Informal document No. 8

(28th GRSP, 27 November - 1 December, agenda item 2.5.)

A United Kingdom proposal for amending

Regulation No. 29

Annex 1 - Appendix 3
Figure 3

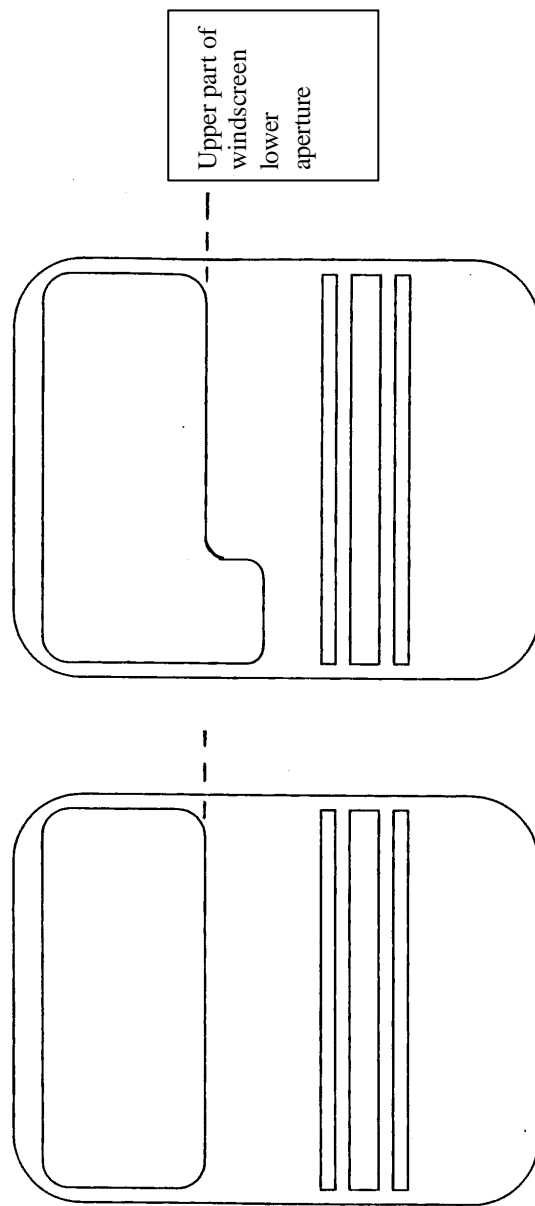
28. 4.1.5.3.1 If the windscreen is stepped this shall be the longest edge or if an equal split the upper edge. See figure 3a and 3b
29. 4.1.6. Create a new 4.1.6 as follows:"The outermost edge of the swing-bob shall be between two parallel vertical planes 30mm apart, the inner one of which is parallel to the mean longitudinal plane and tangential to the outermost part of the drivers door not including any fitted projections such as, but not limited to, door handles, mirrors and trim. See figure 4."
